# SITE PLAN DOCUMENTATION:

**Legal Description & Location:** 6301 Uptown Boulevard NE & 6401 Uptown Boulevard NE (Northwest corner of Uptown and Americas Pkwy)

**Job Description:** Approval of a minor amendment to an SDP approved prior to the IDO to allow a permitter fence.

6-20-2023:  
 AMENDMENTS TO REMOVE TRACT B-1-A-1 FROM SITE PLAN AND TO ADD A PERIMETER SECURITY FENCE ON TRACT A-2-B-1A

**SP-BUILDING PERMIT**

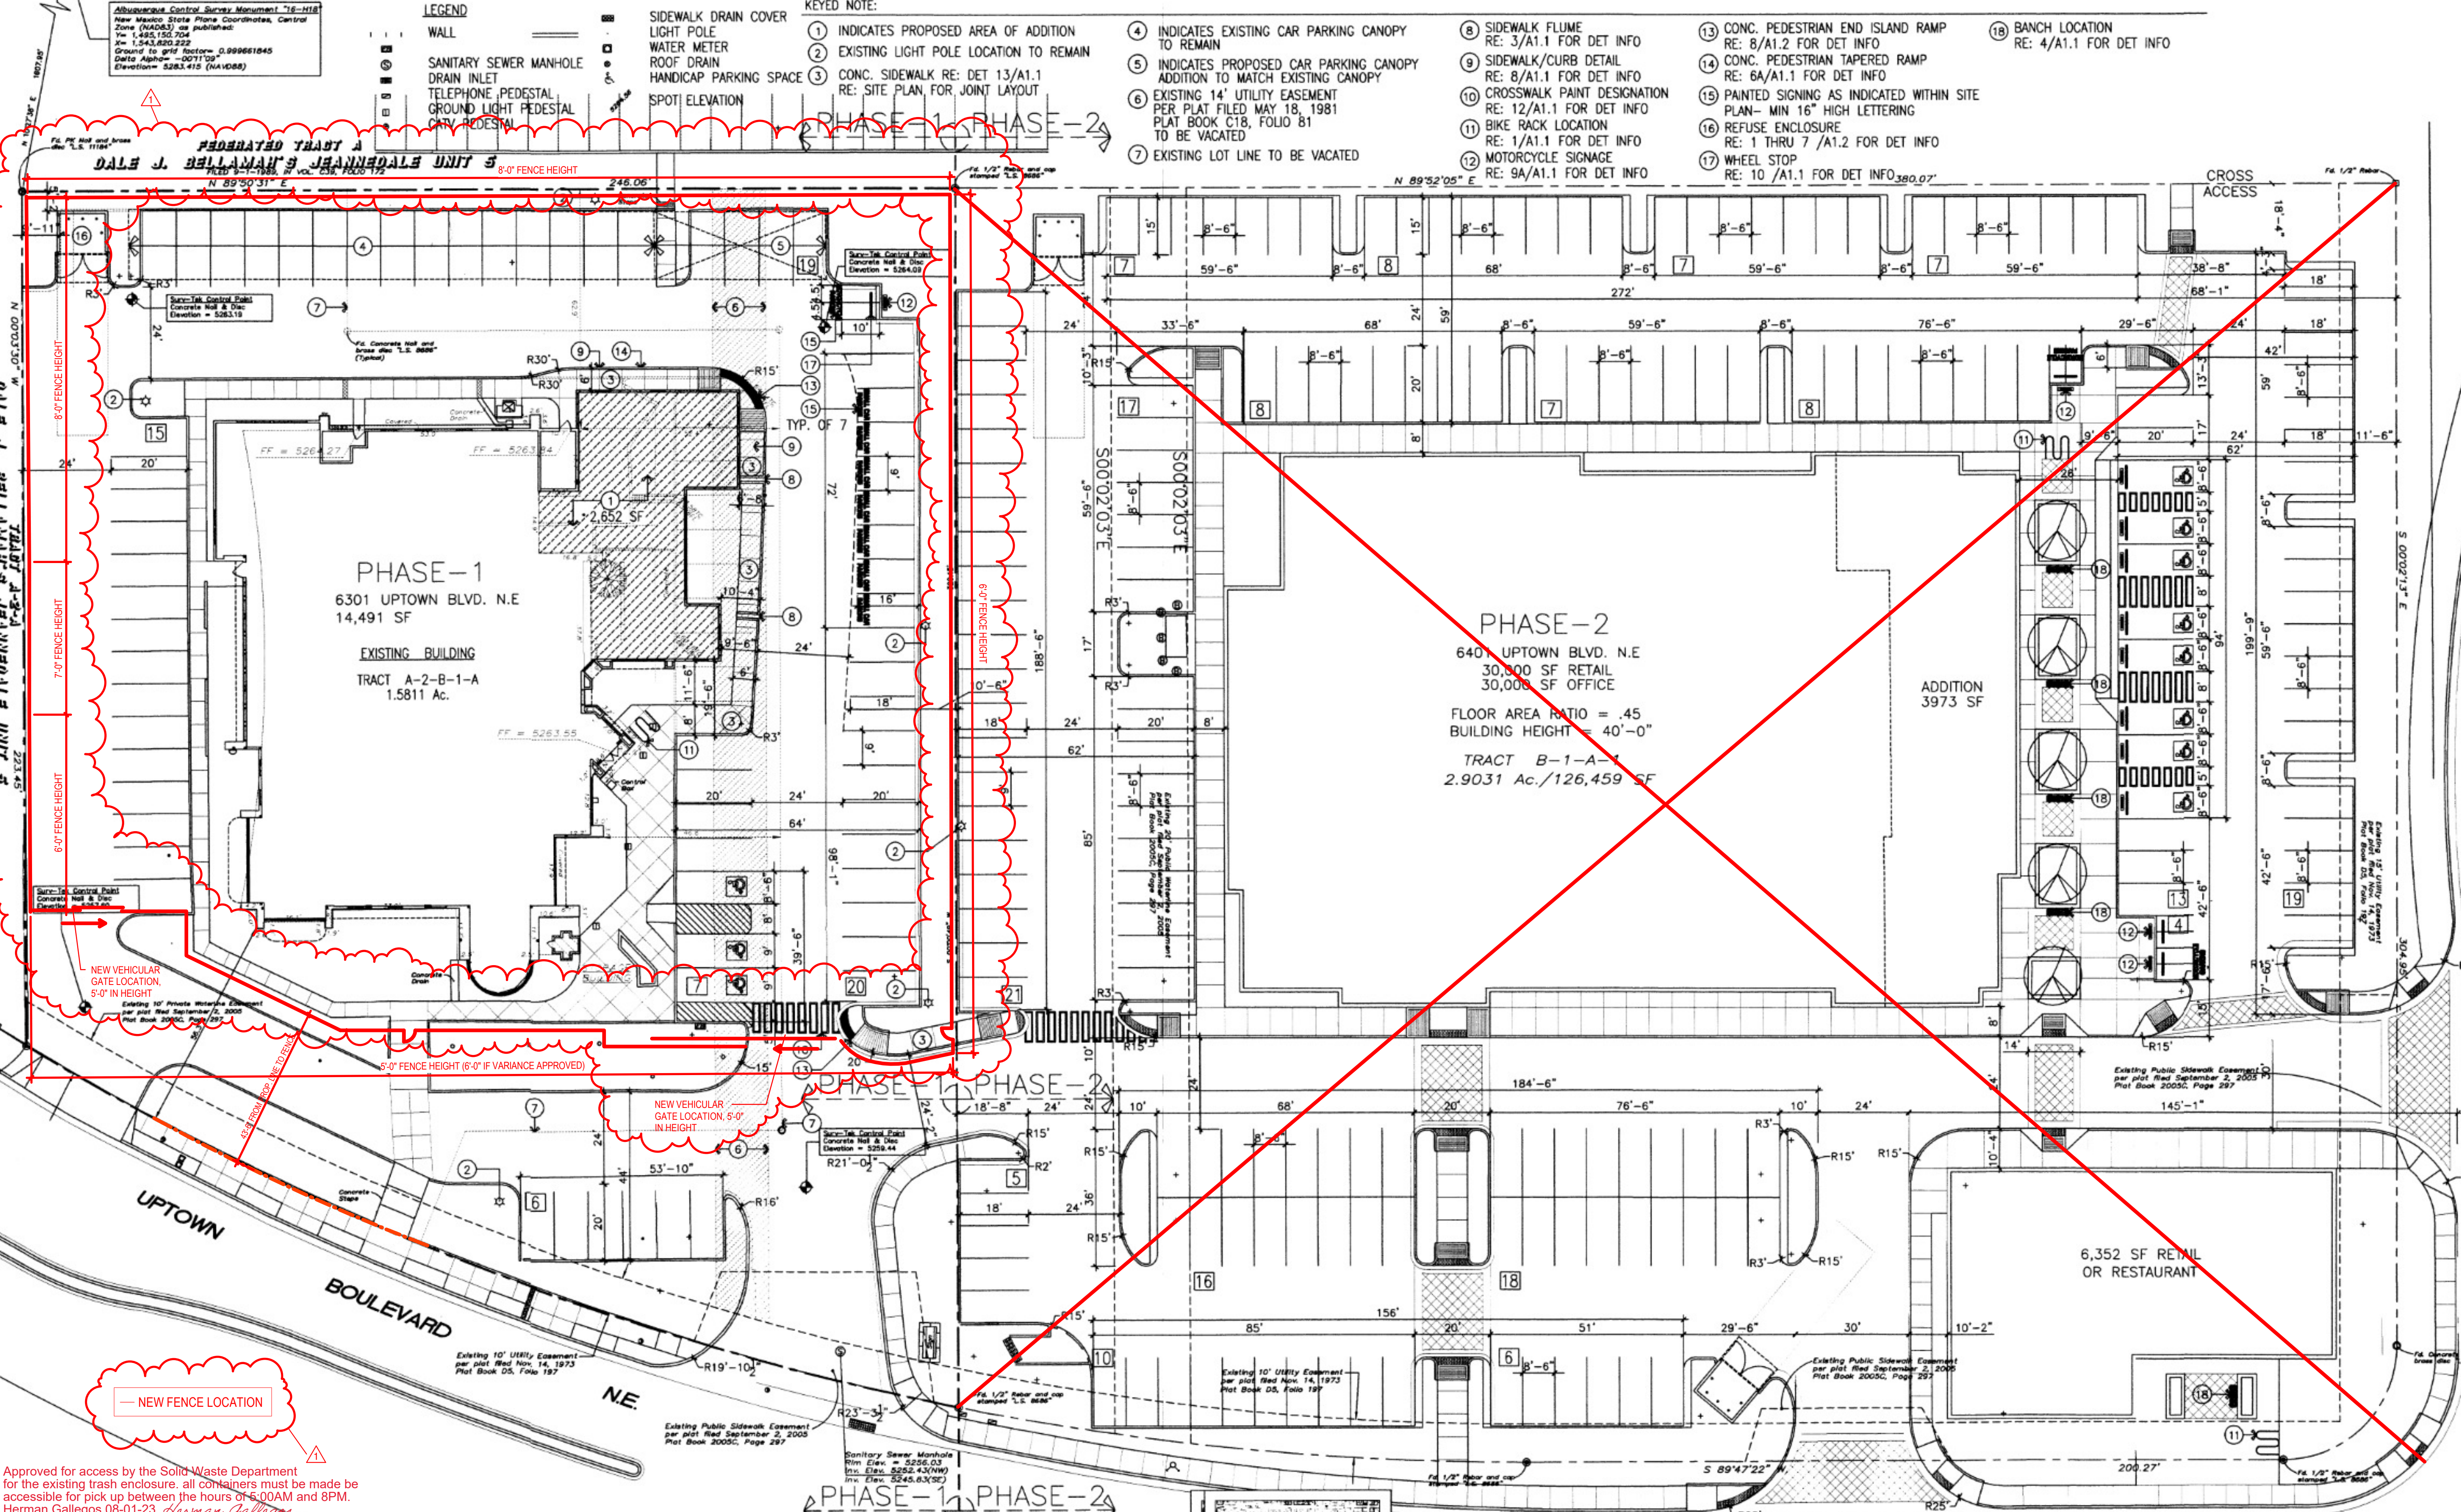
Approved for access by the Solid Waste Department for the existing trash enclosure. all containers must be made accessible for pick up between the hours of 5:00AM and 8PM.  
 Herman Gallegos 08-01-23 *Herman Gallegos*

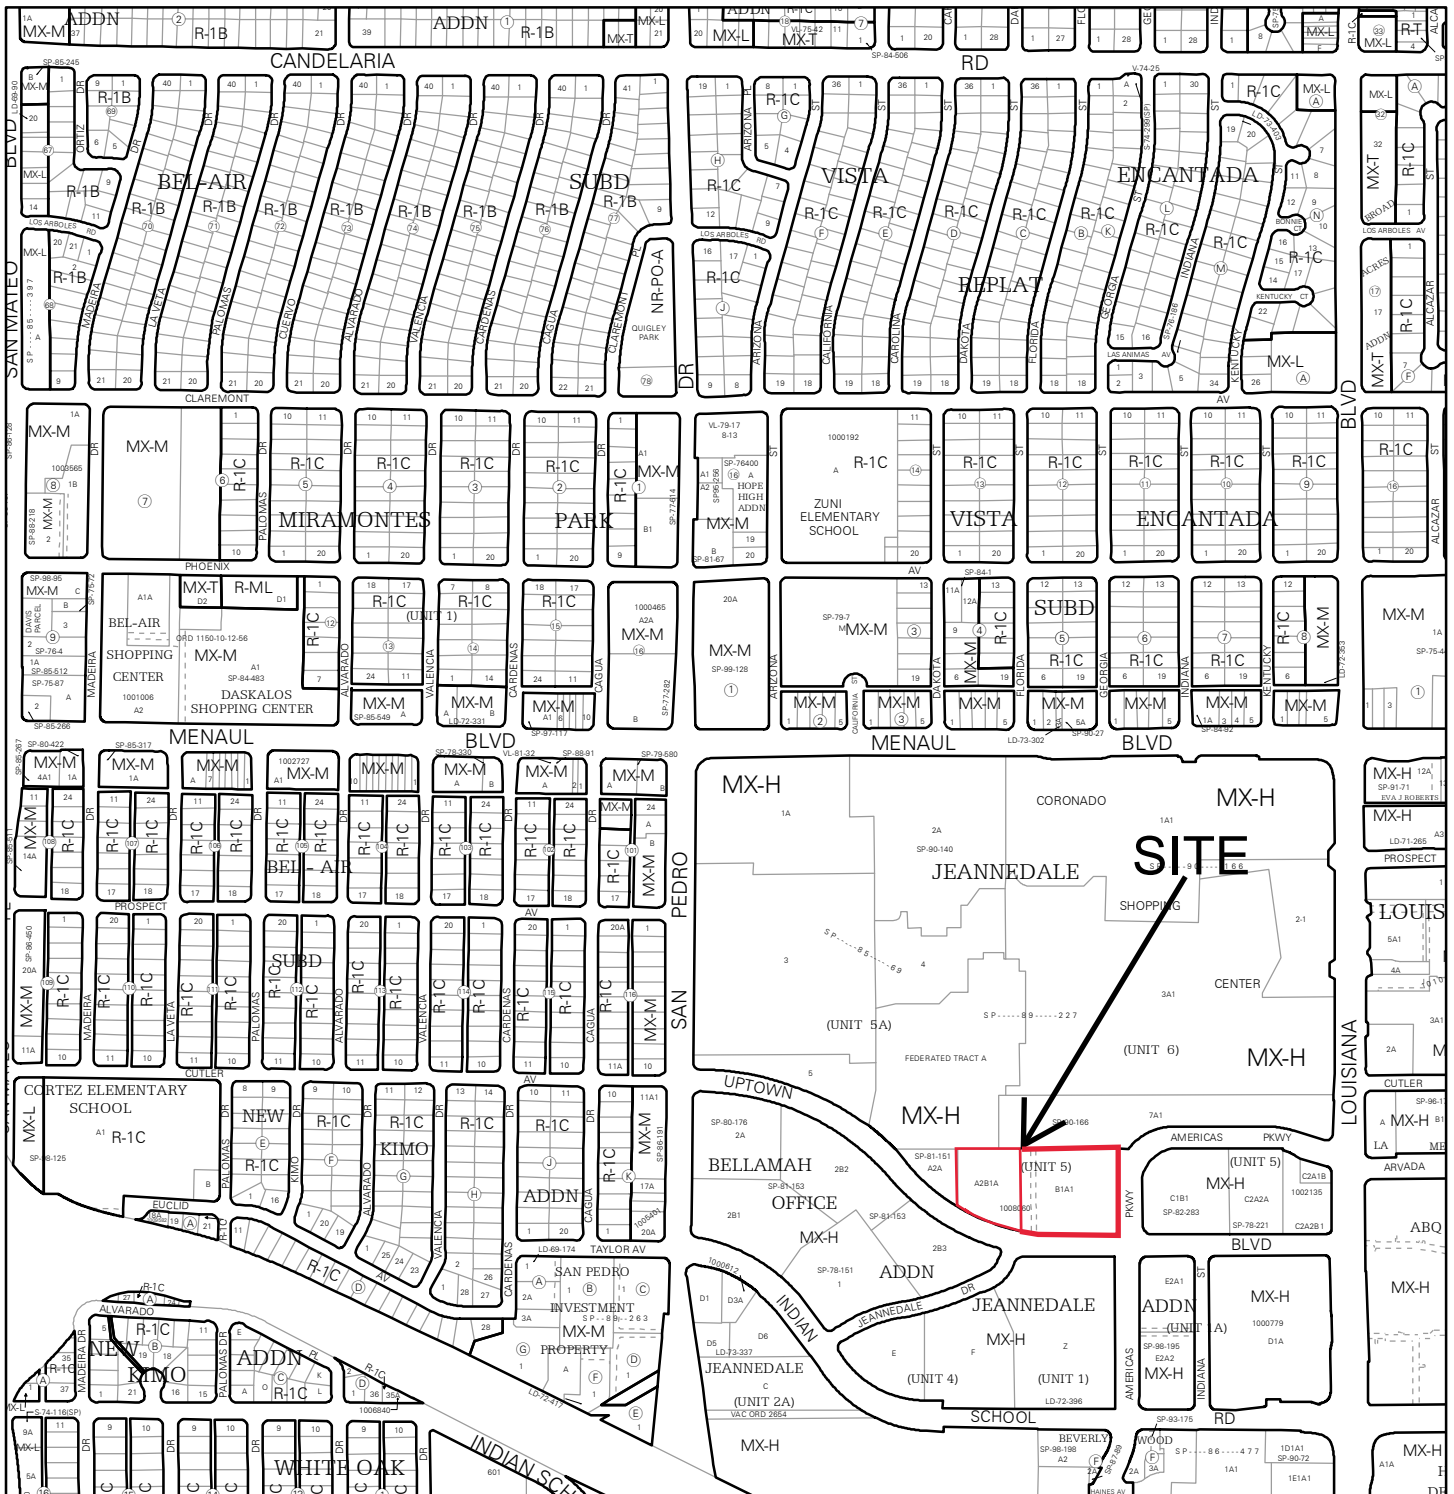
Just checking in with you regarding Fire and Rescue's approval of the Site Plan at 6301 Uptown Blvd. NE showing the fence line to make sure that emergency access to the property is not being impeding or blocking any fire hydrants.

An official fire 1 is not required from us. What we would like to see is a site plan showing the fence line to make sure that emergency access to the property are not being impeding or blocking any fire hydrants. If you have any questions please let me know.

Sorry for the delay. Albuquerque Fire Marshals office have no issues with the proposed site plan with the security fence.
